Working Party on Passive Safety

Sixty-fifth session

Report of the Working Party on Passive Safety on its sixty-fifth session

Figure A SAE J211 sign convention

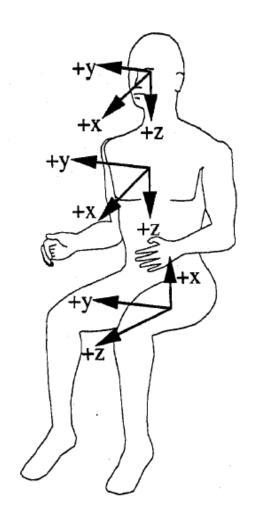
Amend paragraph 7.1.4.2.2. to read:

"7.1.4.2.2. The vertical component of the acceleration from the abdomen towards the head, "-z", when the measurement procedures defined in paragraph 8.5 of this document are followed, shall not exceed 30 g except during periods whose sum does not exceed 3 ms. The measurement procedures defined in paragraph 8.5 of this document follow those of ISO 6487 with SAE J211 sign convention, as shown in Figure A.

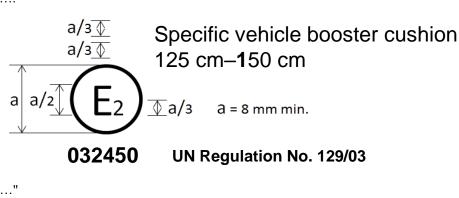
Annex 2, amend to read:

1. Arrangements of the approval mark

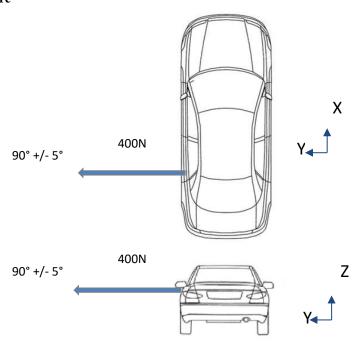
Paragraph 5.4.2.1, amend to read:

"5.4.2.1. The door shall remain latched;
